APPROVALS		TITLE:	
INIT	DATE	BACKLINE 112 PRE-AMP	
DESIGNED: R.A.G.	10/01/01	SIZE	DRAWING NO: 406-0150-A
DRAWN: R.A.G.	10/8/01	B	PART NO: 206-0150-A
ELEC:		COMPANY: GALLIEN-KRUEGER	
MECH:		FILENAME: 6150A Backline 112 Preamp.sch	
Q/A:			
RELEASED:

Bill of Materials Backline 112/110 Preamp 206-0150-A

Customer Name:		Gallien-Krueger		Current Rev #:		A1		New ECO Rev #:		A2	
Model:		Backline 110/112				Page:		1		Of: 1	
Assembly Description:		Preamp Assembly		Originator:		Bob Gallien					
Assembly Numbers:		206-0150-A1		Approved by:							
				Effective Date:		12/21/2001					
Effective				Document Update				Date		Initials	
<input checked="" type="checkbox"/>	All in Process	<input checked="" type="checkbox"/>	Next Buy	<input type="checkbox"/>	Artwork						
<input type="checkbox"/>	All in Service	<input checked="" type="checkbox"/>	Next Production Run	<input type="checkbox"/>	Assembly Dwg.						
<input type="checkbox"/>	All in Stock	<input type="checkbox"/>		<input type="checkbox"/>	Auto Insert Pgm						
Beginning Serial Number:				<input type="checkbox"/>	Board Artwork						
Reason For Change				<input checked="" type="checkbox"/>	BOM	#####					AV
The Overdrive B channel has too much g

APPROVALS		TITLE: BACKLINE 110/112 PRE-AMP	
INIT	DATE	REV	REV
DESIGNED: R.A.G.	10/01/01	DRAWING NO:	406-0150-A3
DRAWN: R.A.G.	3/26/02	PART NO:	206-0150-A3
ELEC:			A3
MECH:		COMPANY:	GALLIEN-KRUEGER
Q/A:		FILENAME:	6150A3 Backline 112 Preamp.sch
RELEASED:

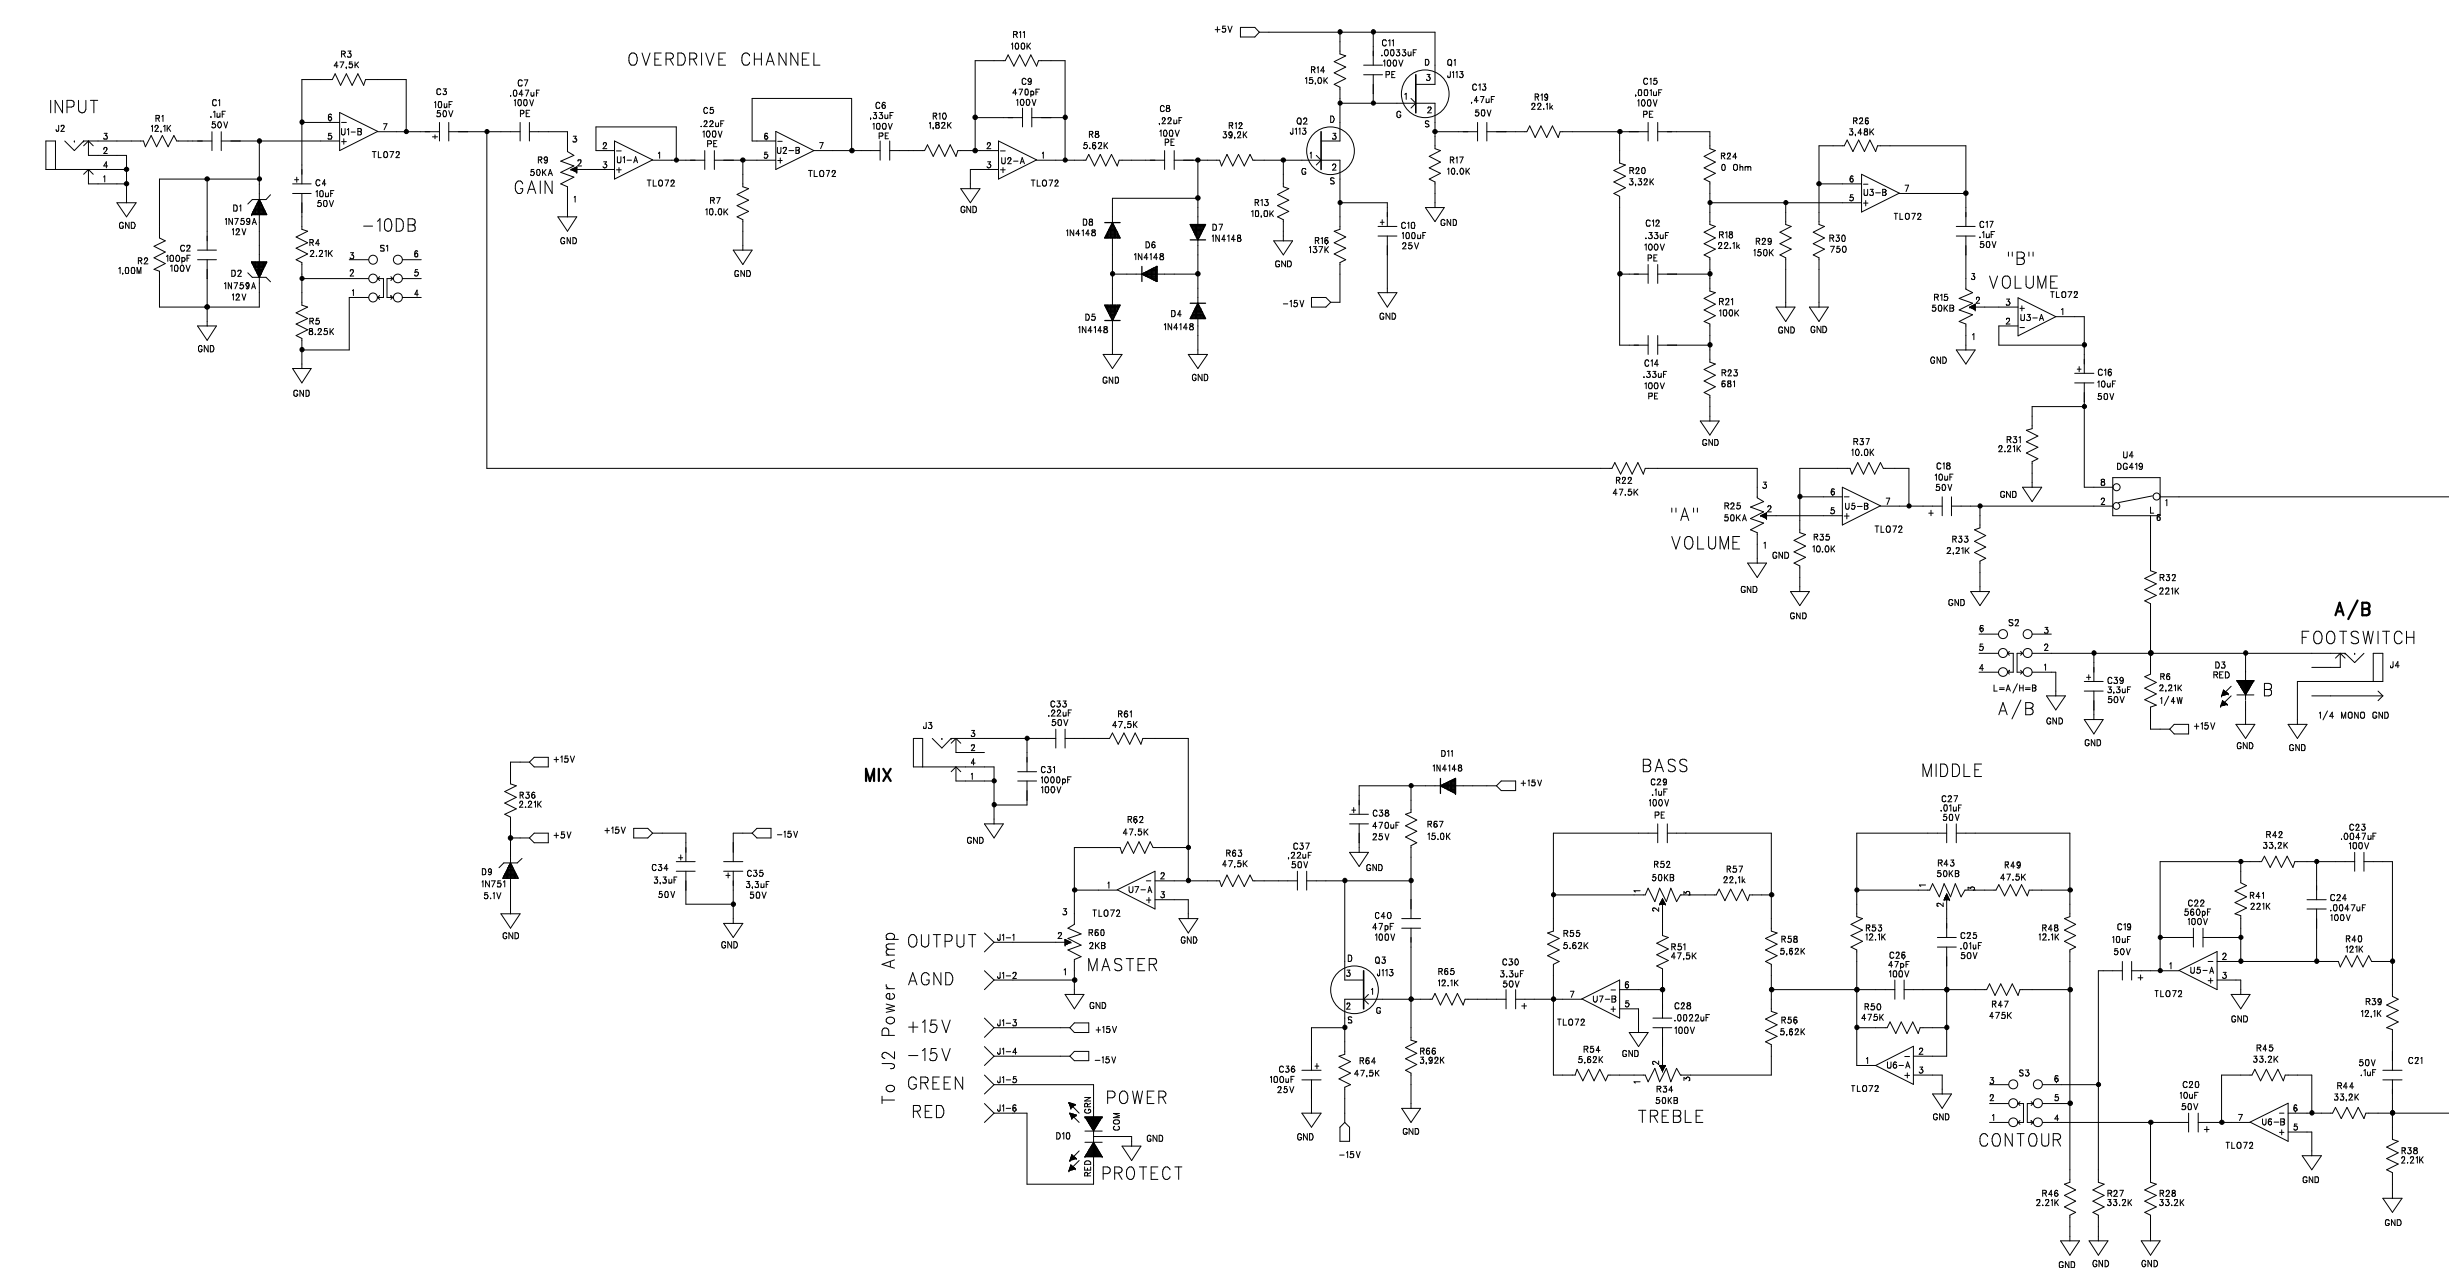
1. Remove R59 and C32.

DRAWING NO:	406-0150-B
PART NO:	206-0150-B
COMPANY:	GALLIEN-KRUEGER
FILENAME:	6150B

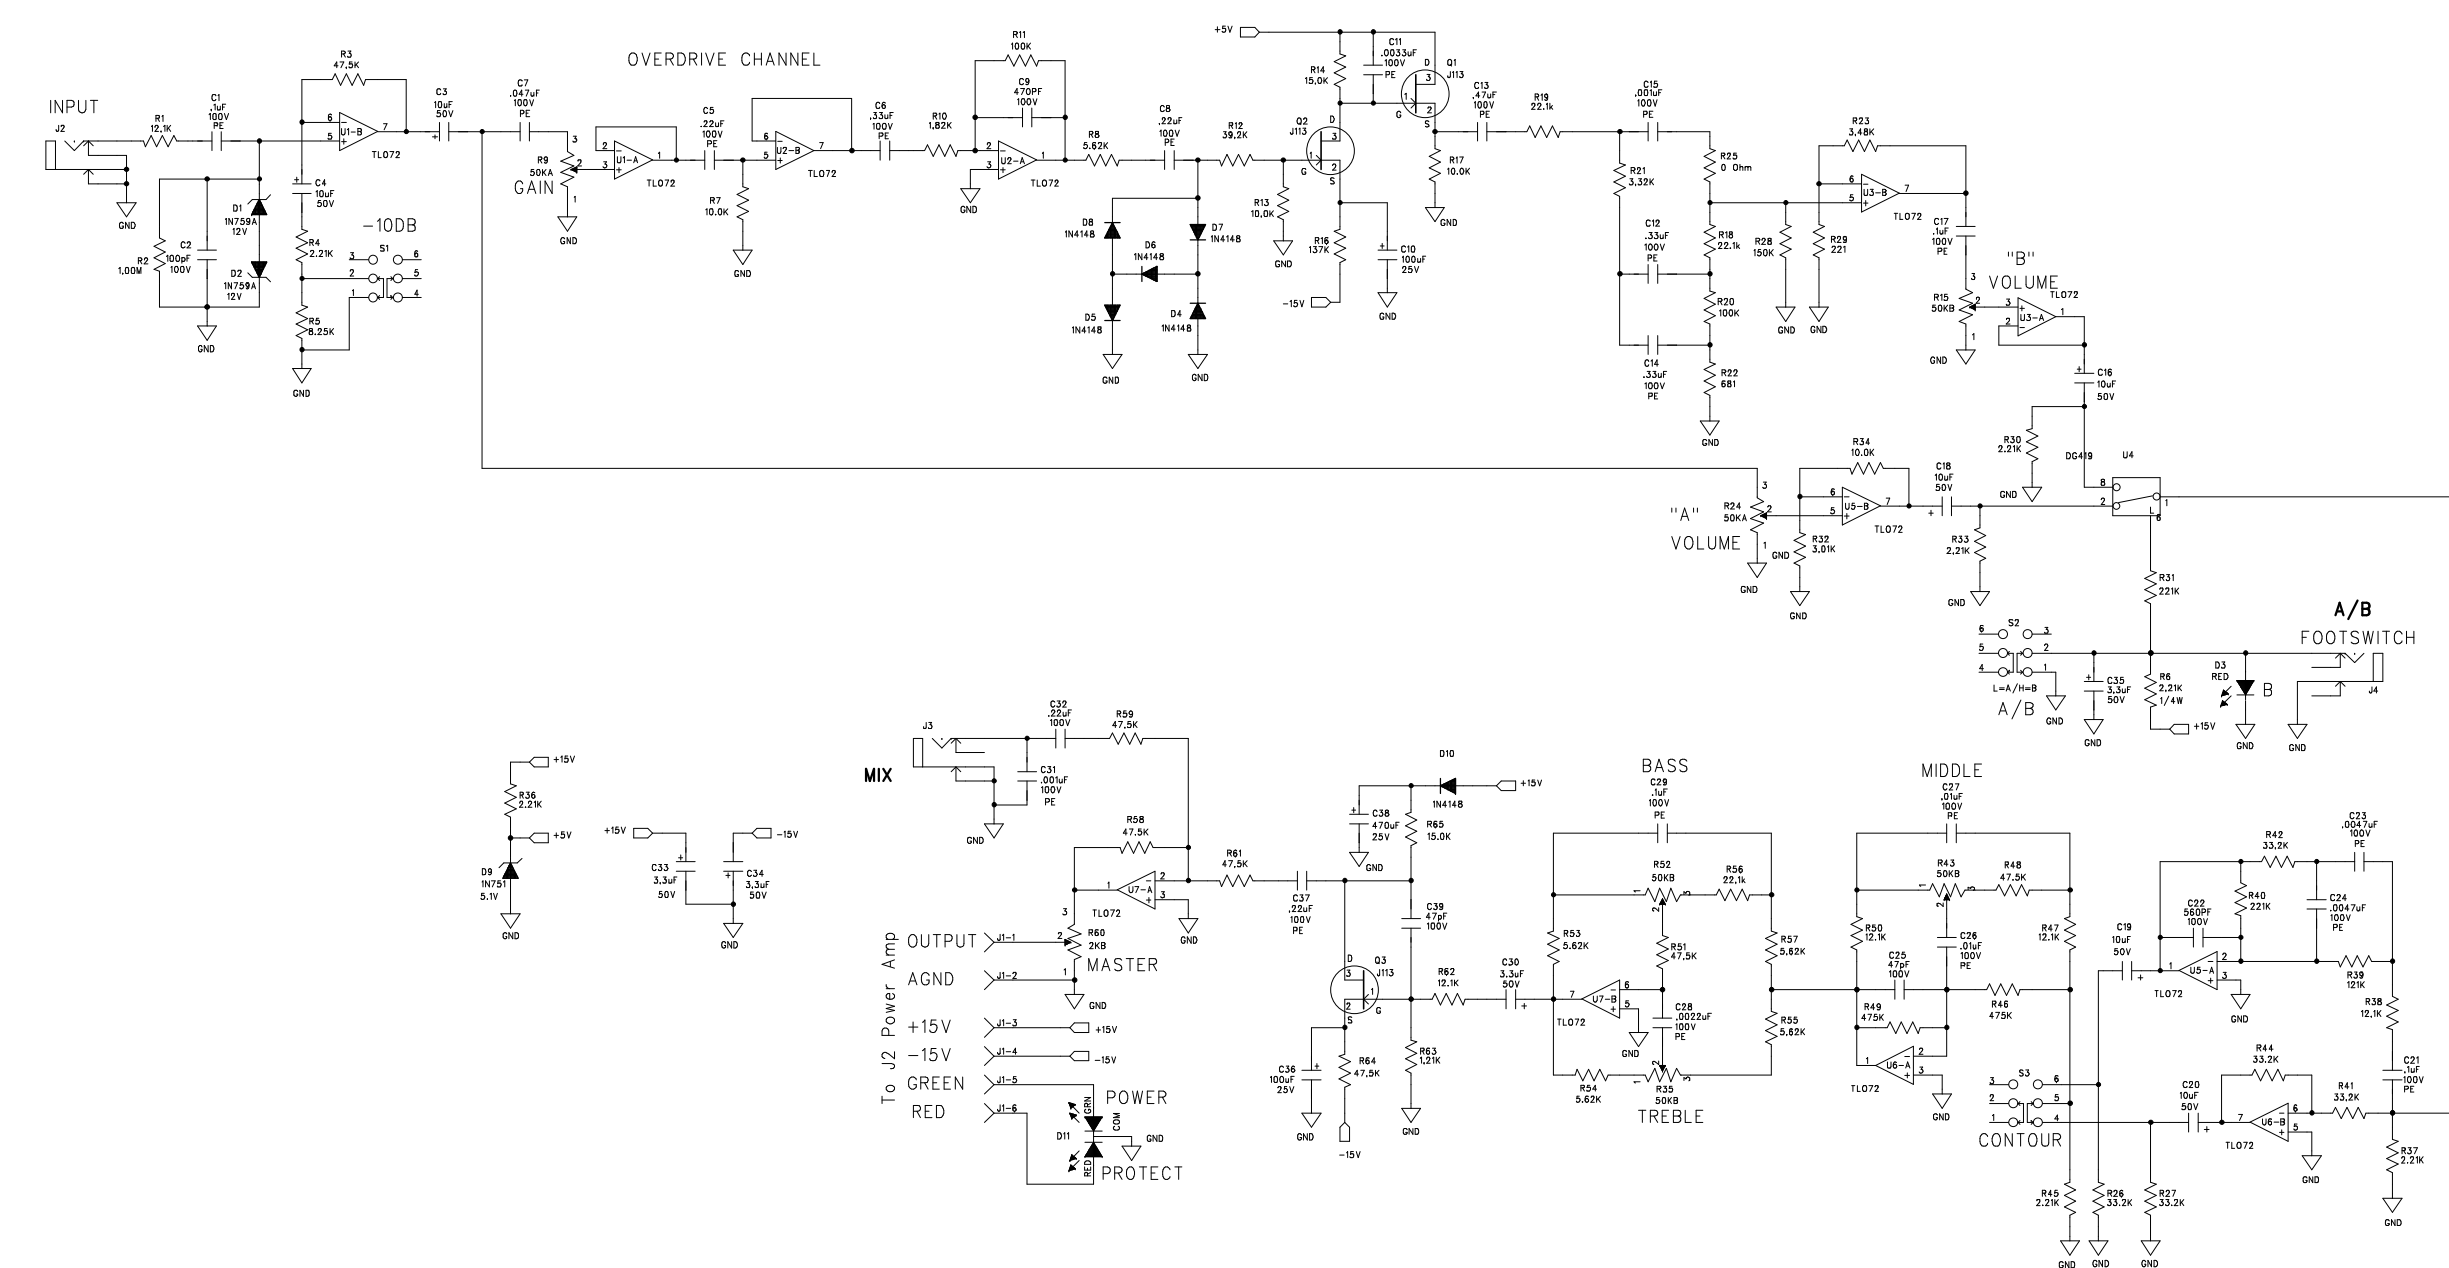
1. Change all axial ceramic caps to polyester or radial ceramic.
2. Enlarge transformer notch to end of board and make .1 inch deeper.
3. Change R30 to R29 = 221.
4. Change R35 to R32=3.01K
5. Change R 66 to R63=1.21K
6. Delete R22 from rev A3.

Enlarge transformer notch.				<input type="checkbox"/>	Fab Drawing				
Increase post Volume gain on Channel B.				<input type="checkbox"/>	Inspection Proc.				
Increase post Volume gain on Channel A.				<input checked="" type="checkbox"/>	Part Master File		RAG		
Reduce post EQ gain before Boost.				<input checked="" type="checkbox"/>	Schematic	8/28/2002	RAG		
Increase Pre Volume-A gain.				<input type="checkbox"/>	Service Manual				
Updated A3 changes to board layout.				<input checked="" type="checkbox"/>	Test Procedure		Noli		
B1-Add cabinet simulator circuits.				<input type="checkbox"/>					
B2-Add pots with support brackets.				<input type="checkbox"/>					
				Other Affected Assemblies					
				290-0200,303-2200,303-0200					
				303-1200					
<input type="checkbox"/>	Continued on ECO Supplement Page								
Description Of Change				Distribution		Date	Initials		
B -Set R29=221.				<input type="checkbox"/>	Accounting

Set R32=3.01K				<input type="checkbox"/>	Assembly				
Set R63=1.21K				<input type="checkbox"/>	Customer				
Delete R22 (as on Rev A3).				<input checked="" type="checkbox"/>	Engineering				
B1-Add R24,30,31,C17,18.				<input checked="" type="checkbox"/>	Incoming Q.C.				
B2-Change layout to accommodate pot brackets.				<input type="checkbox"/>	Planning				
				<input checked="" type="checkbox"/>	Production Eng.				
				<input checked="" type="checkbox"/>	Purchasing				
				<input type="checkbox"/>	Q.A.				
				<input type="checkbox"/>	Receiving				
				<input checked="" type="checkbox"/>	Service				
				<input checked="" type="checkbox"/>	Test				
Use B2 BOM.				<input type="checkbox"/>	Vendor				
				<input type="checkbox"/>					
				<input type="checkbox"/>					
				<input type="checkbox"/>					
				<input type="checkbox"/>	Drawing(s) attached				
Part Number	Description	Parts Added		Parts Deleted

APPROVALS		TITLE:		REV.
INIT	DATE	BACKLINE 110/112 PRE-AMP		
DESIGNED: R.A.G.	10/01/01	DRAWING NO:	406-0150-B1	B1
DRAWN: R.A.G.	8/28/02	PART NO:	206-0150-B1	
ELEC:		COMPANY:	GALLIEN-KRUEGER	
MECH:		FILENAME:	6150B1	
Q/A:				
RELEASED:

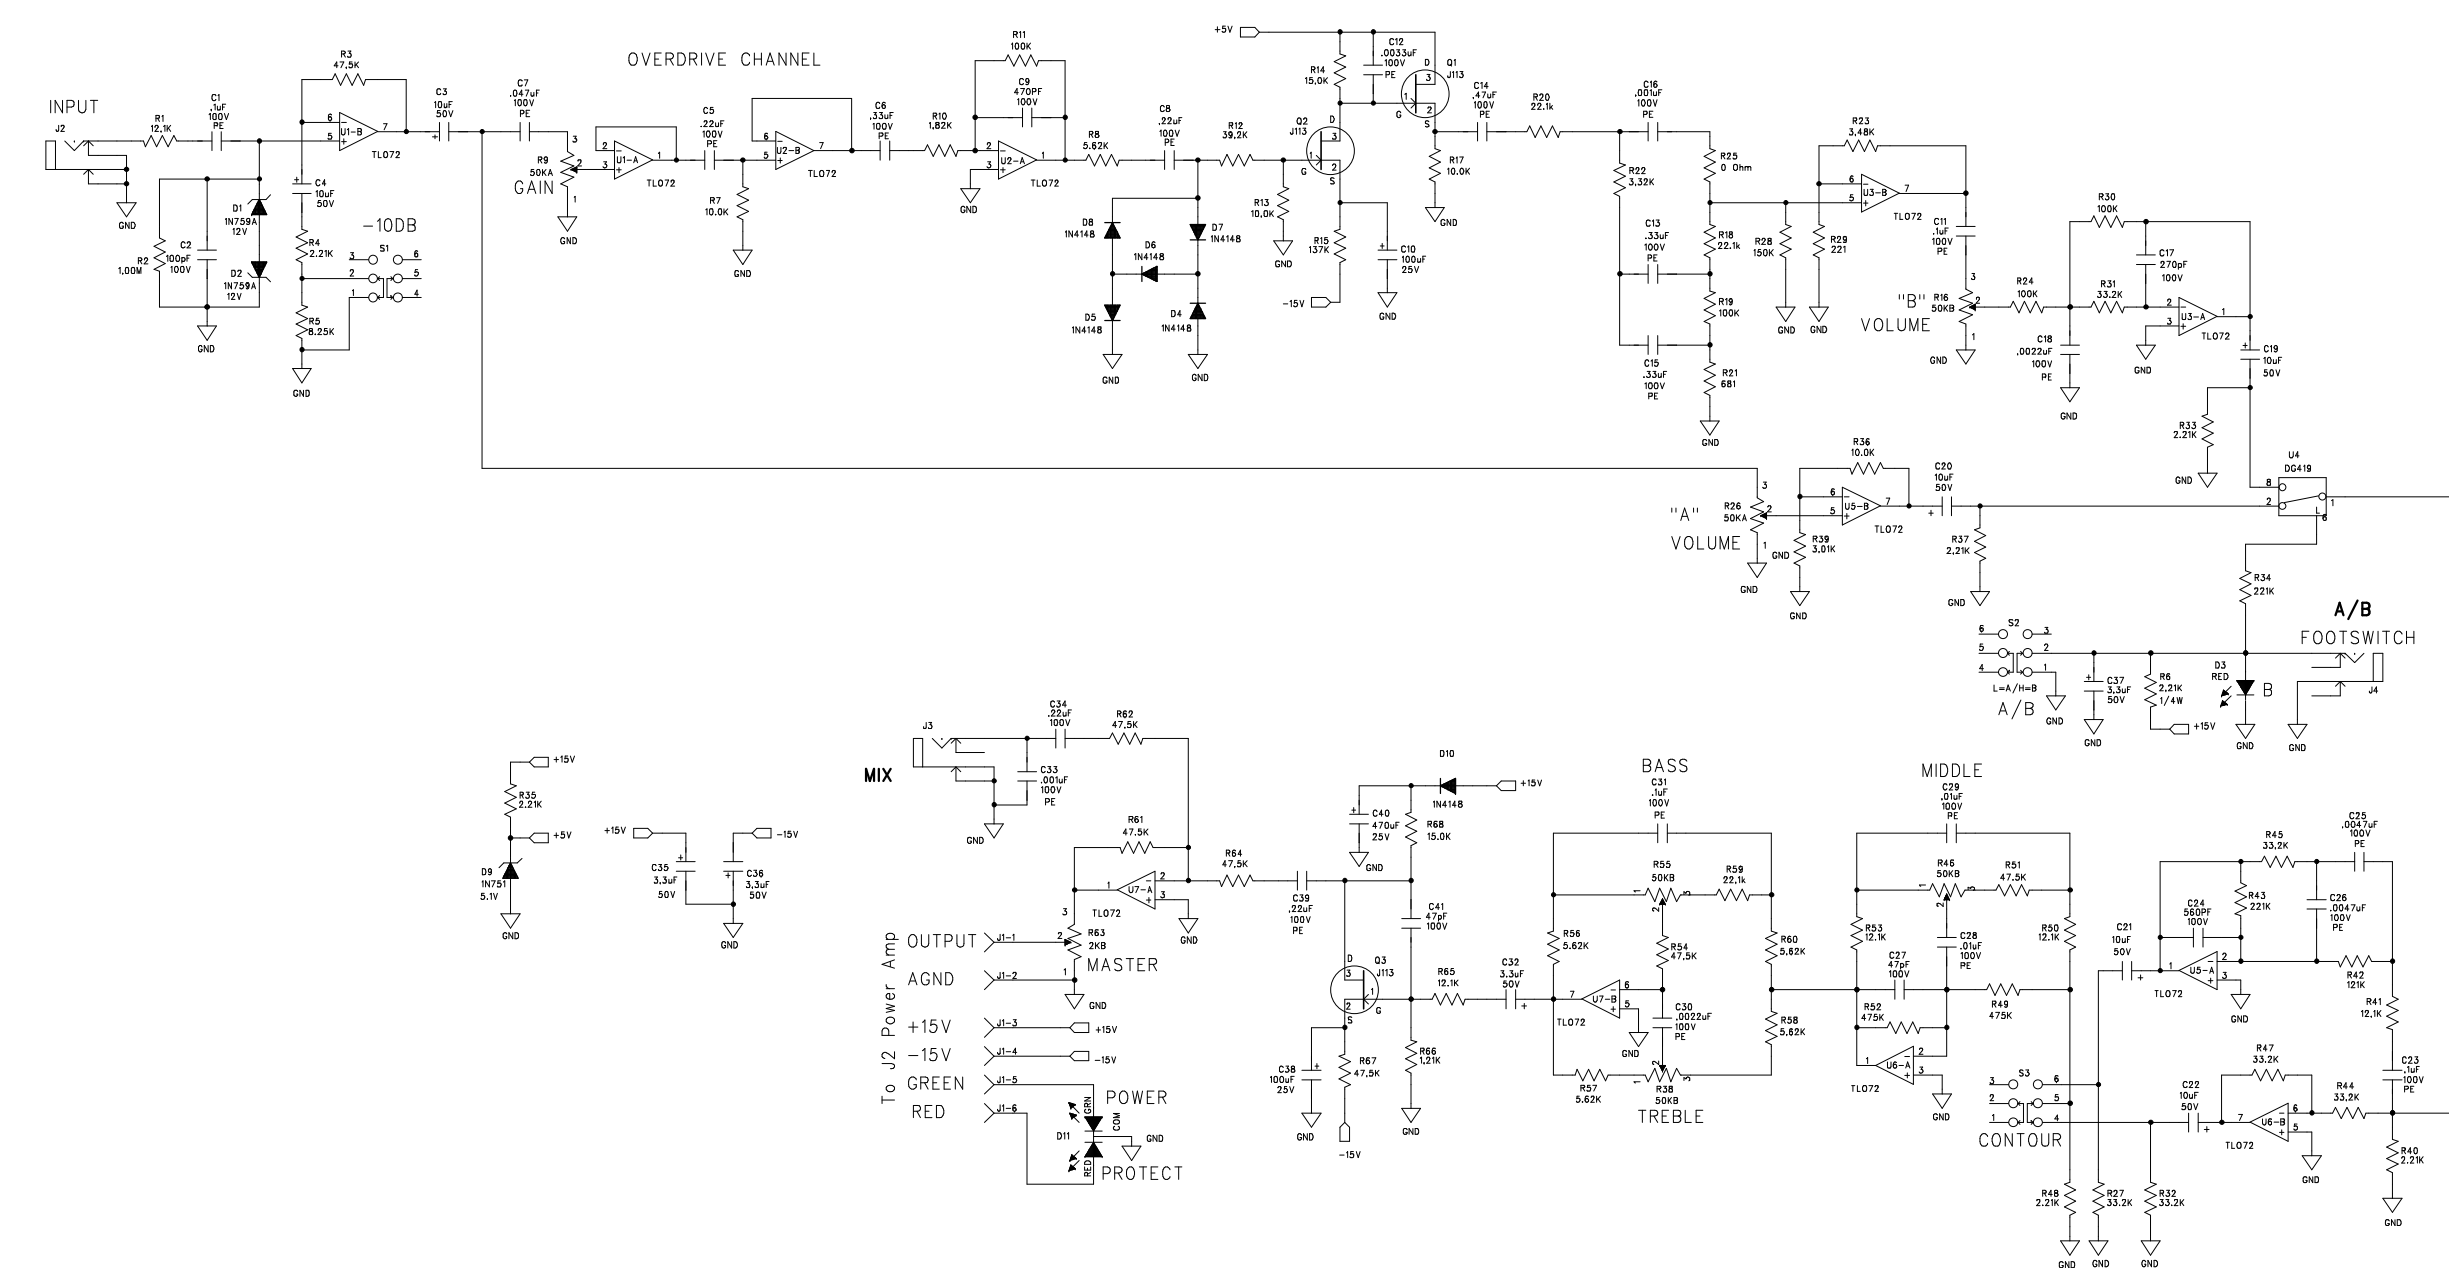
1. ADD CAB SIMULATOR CKT TO USA.

DWG #420-0150-B2

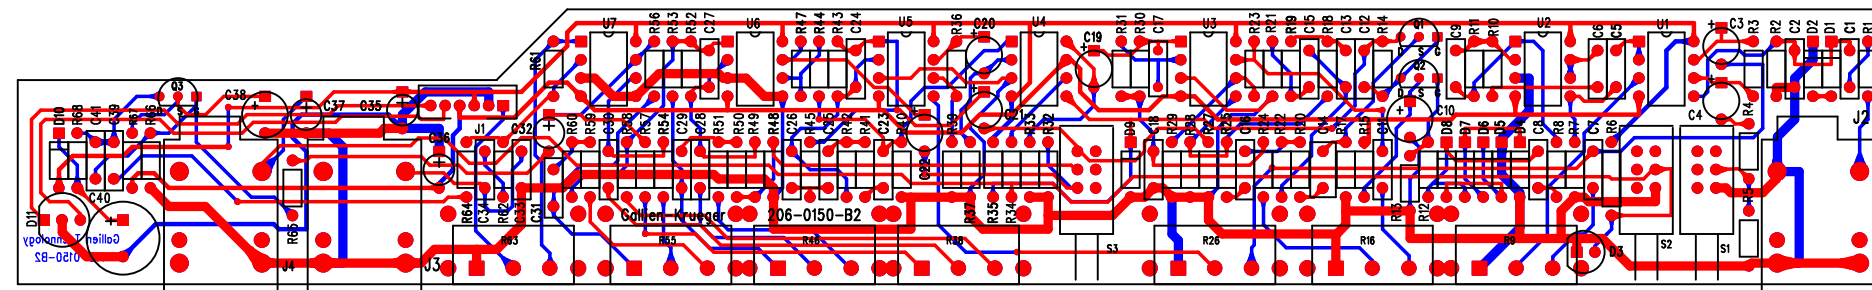
5. CLIP BUSHING TABS OFF ON POTS R9, 16, 26, 38, 46, 55, 63
6. SEE DETAIL A FOR MOUNTING D3
7. SEE DETAIL "B" FOR MOUNTING D11
8. CLIP BRACKET FROM RIGHT SIDE OF R9 TO CLEAR D3.
